# University of Kentucky<sup>®</sup>

CCK-2564.0-9-24

Construct Health Education Building

ADDENDUM #3

**C300**

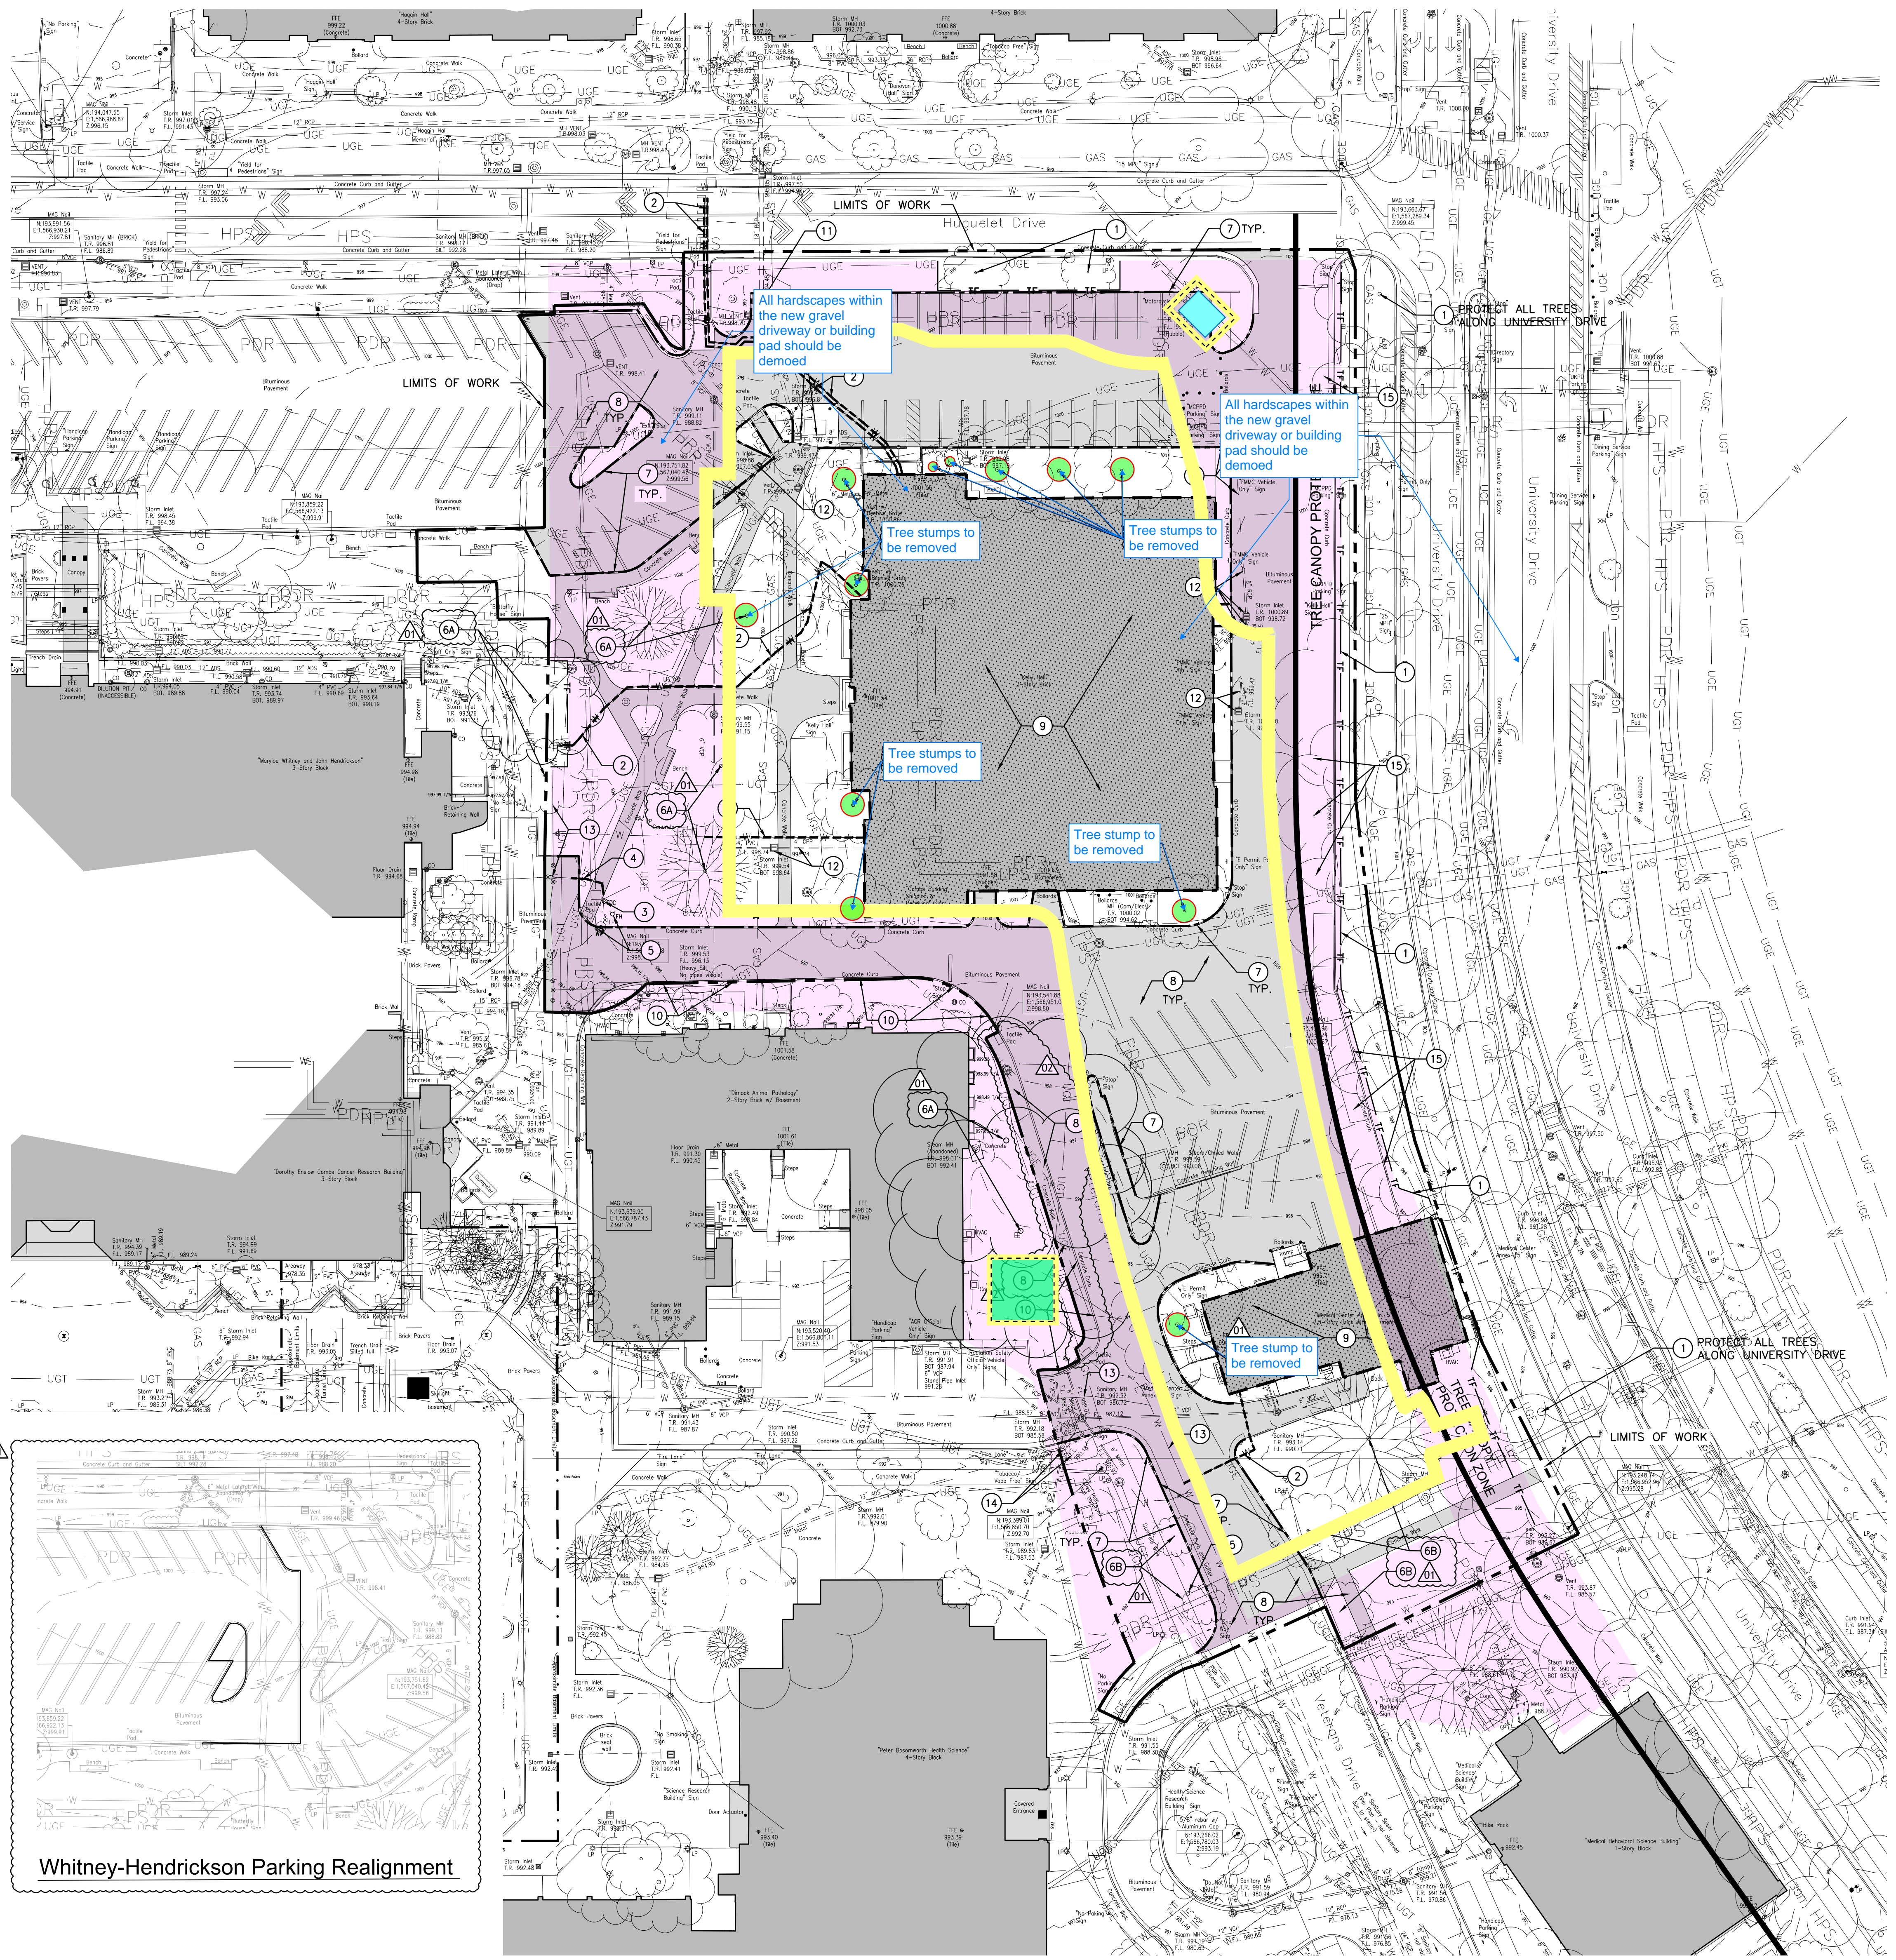
6	Reference Attachment "B", item 23-f-i.: twelve (12) openings in the cable guardrail are to be incorporated into the retention system. Are 36" wide openings acceptable, and will any style special "landing" be required?	36" will suffice for any type of foot traffic. Landings / walkways to be installed by others (future GT).
7	Reference Plan Sheet C300, Keynote 5: "Areas within Building Footprint where rock is lower than designated elevation 982 or 984, shall be filled with 4,000 PSI concrete to subgrade of footings or to 36" from bottom of floor slab". Which Bid Package does this note apply: TC-014 -- Site Excavation or TC-015 -- Foundations? Additionally, where subsequent earth excavation is directed in earthen areas below EL 982 or EL 984, <b>is it not incumbent</b> on TC-014 to design its retention system for the additional height of earth retention relative to said deeper excavation, although TC-015 may be assigned the duty as the party to perform the foregoing undercut with concrete refill (primarily for foundation support)?	Keynote 5 on C300 pertains to TC-015 Foundations. Lagging boards shall go to top of rock.

**S-002**  
COPYRIGHT 2024 - JRA, INC.

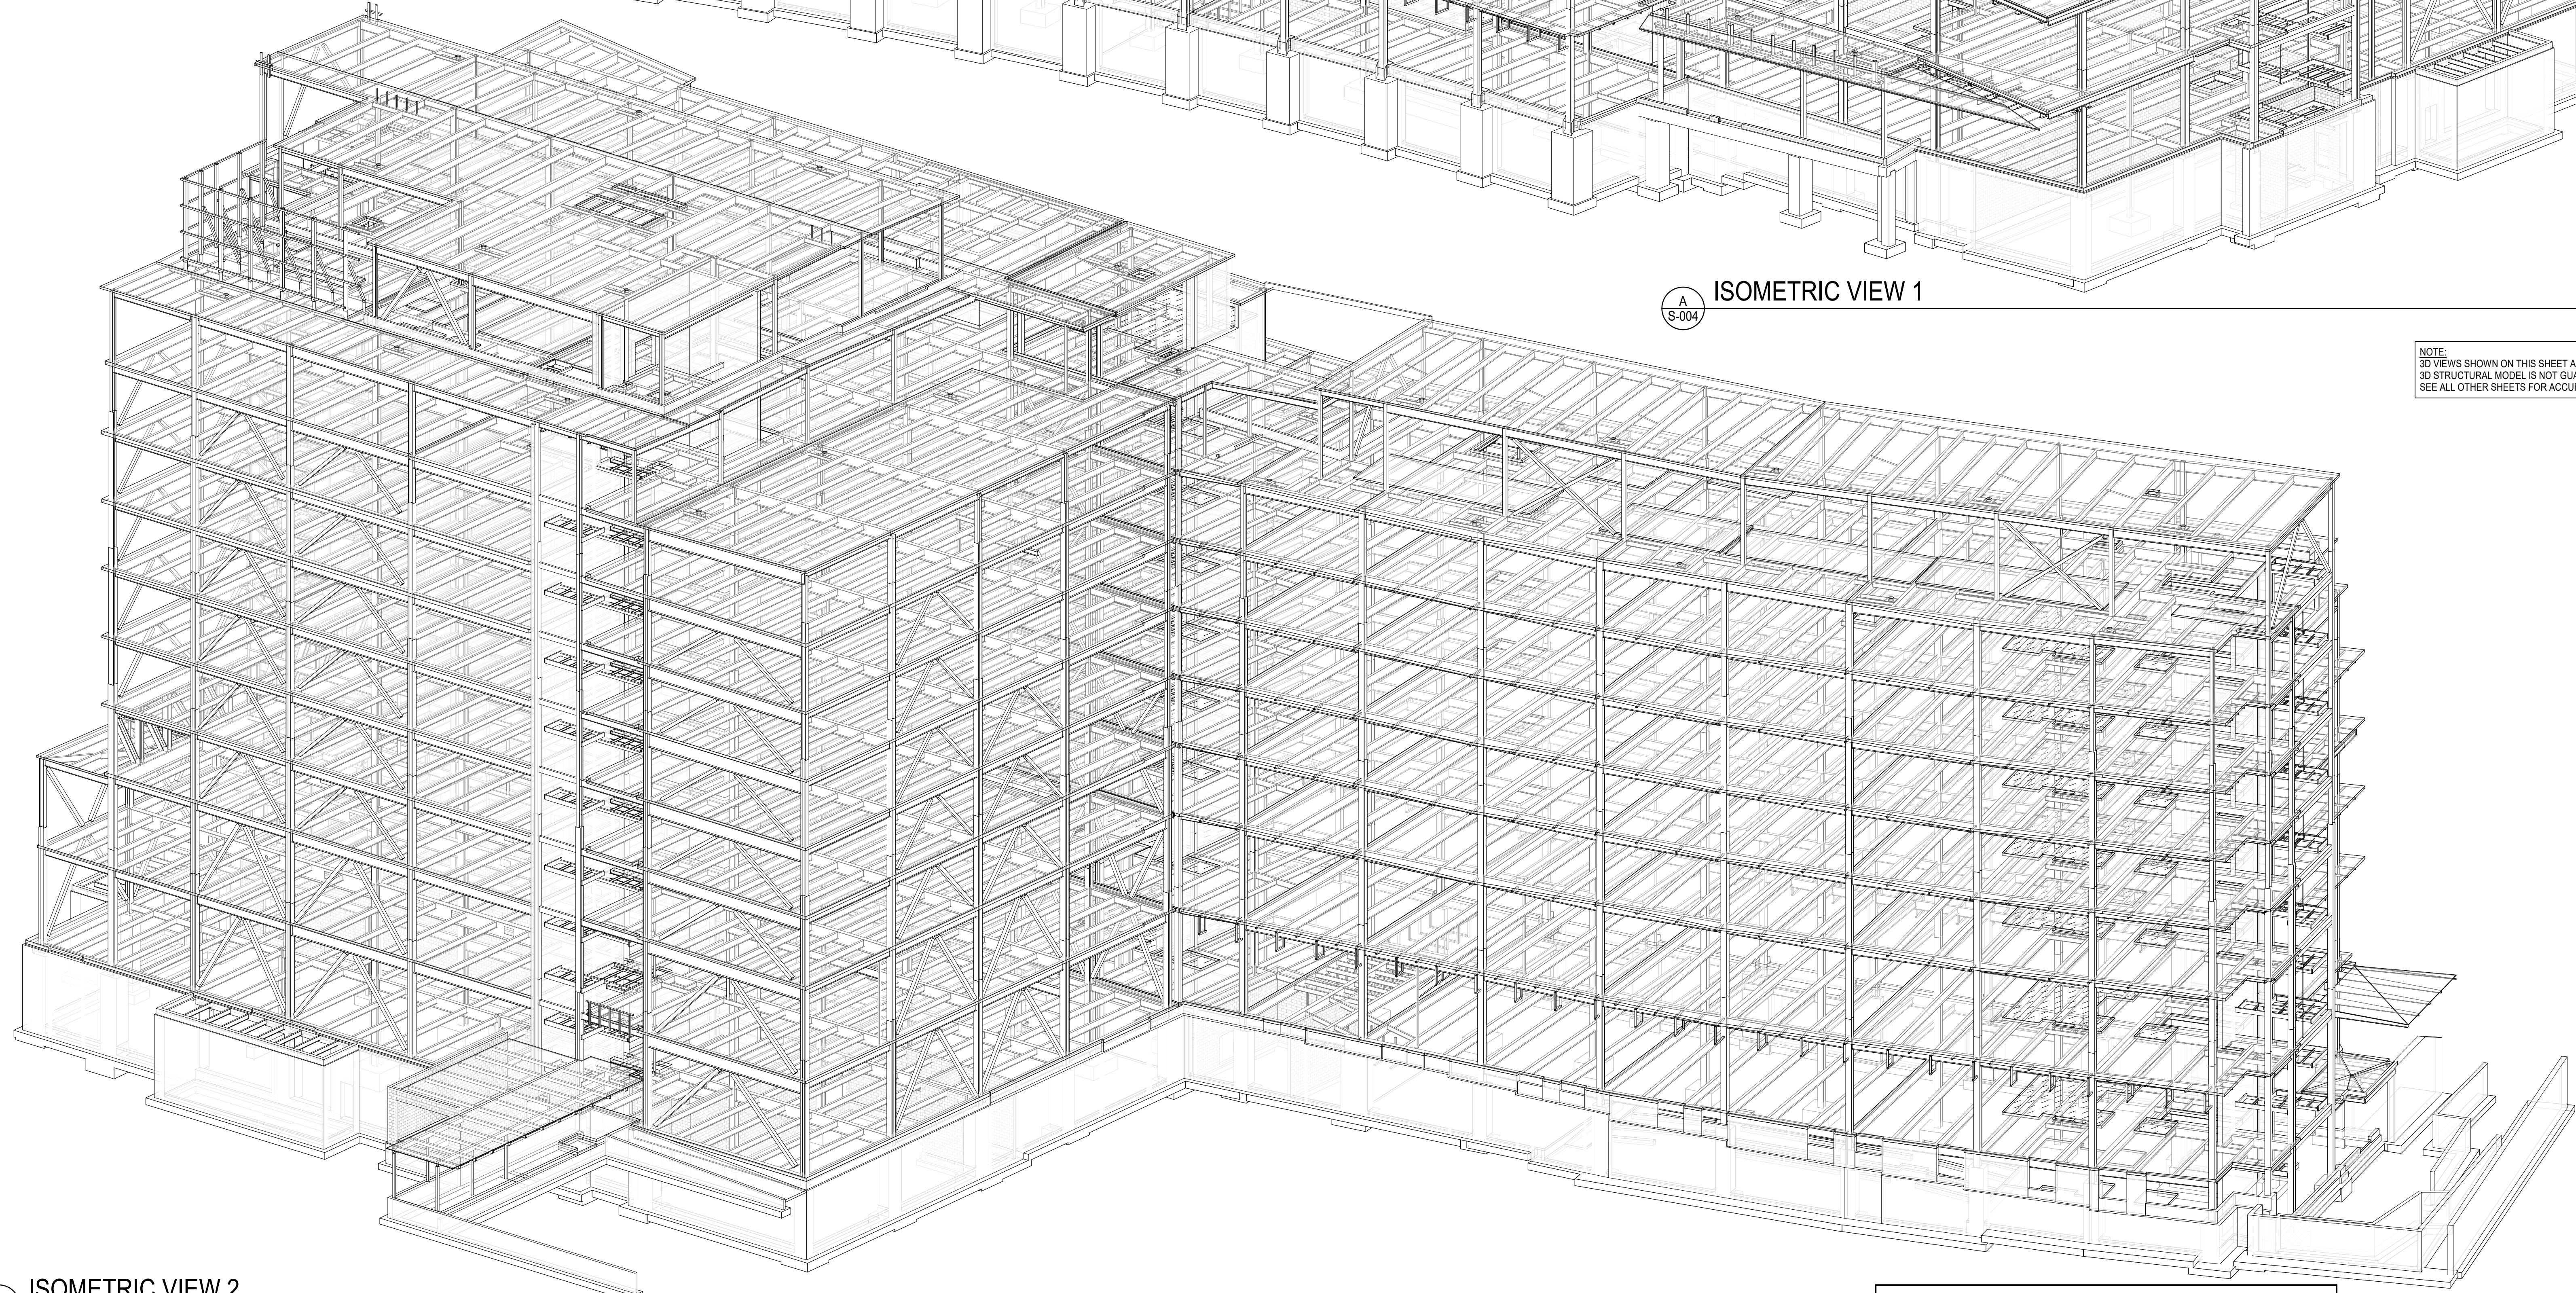
Refer to attached sheet S-002. Abbreviation list has updated. Foundation Tag Notes and Framing Tag Notes have moved from all Plan sheets and are now located on this "General Notes & Structure Tag Notes" sheet.

**S-004**

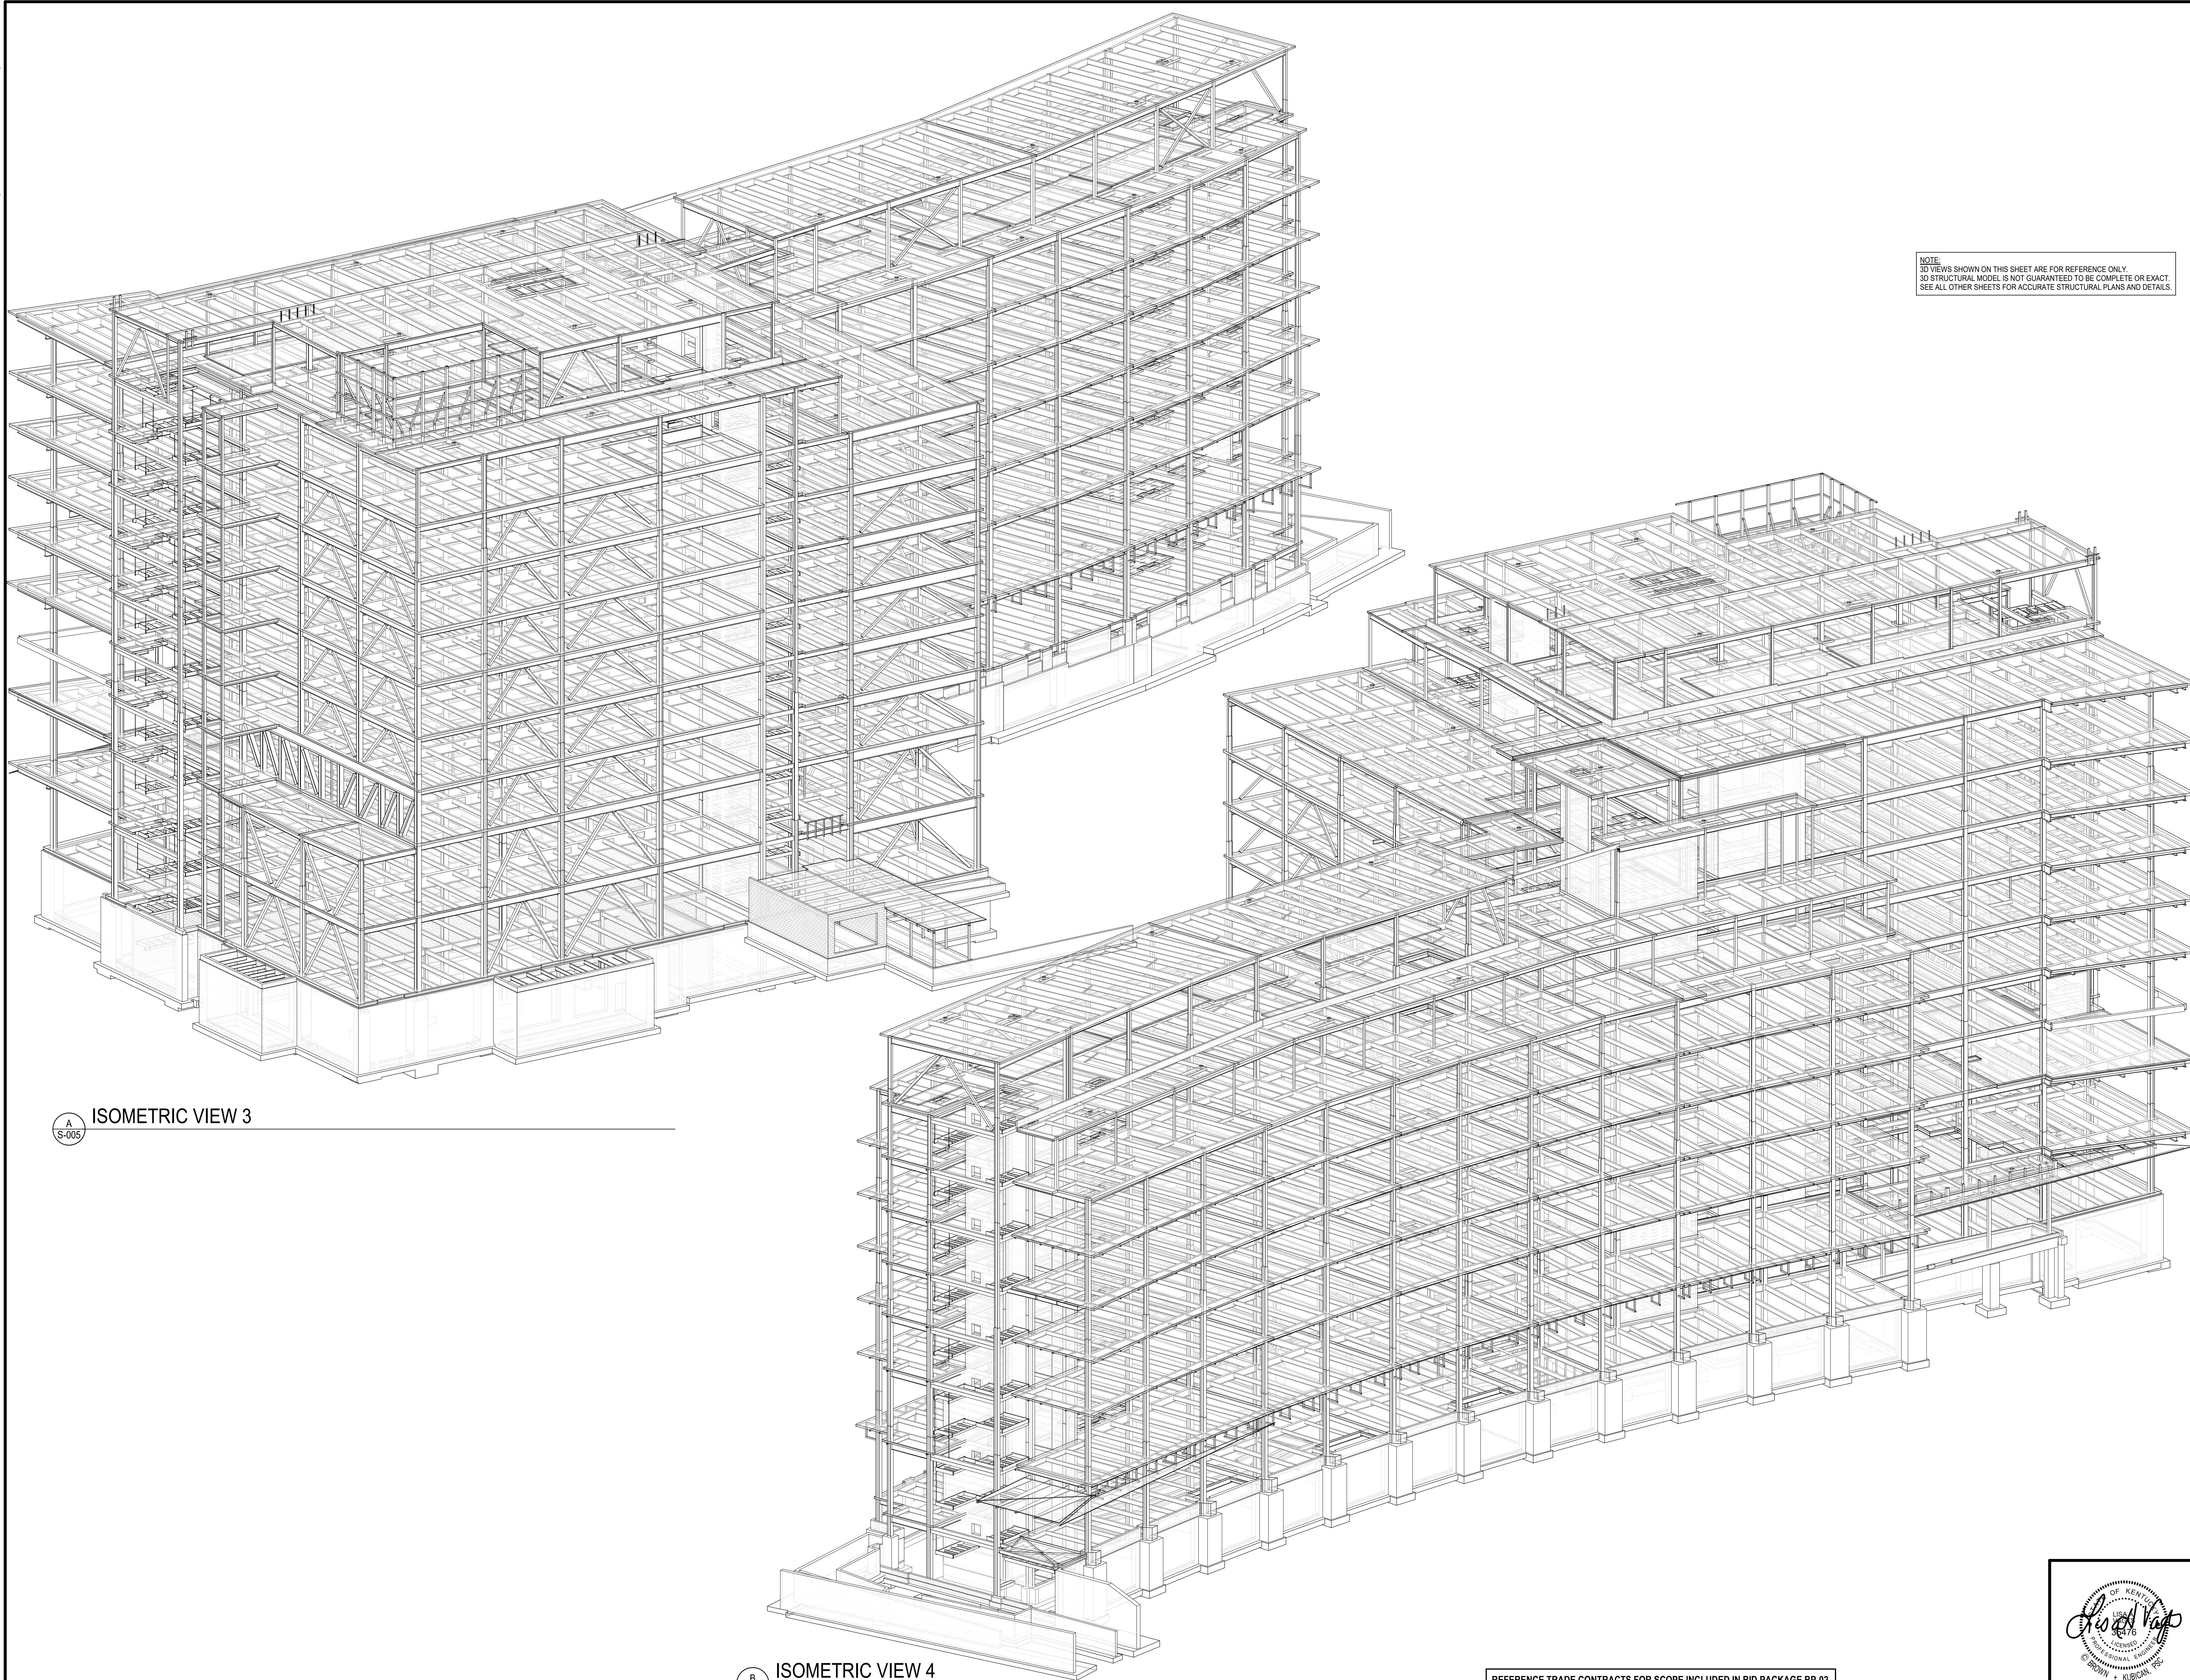
Refer to attached sheet S-004. Updated isometric views included for reference only.
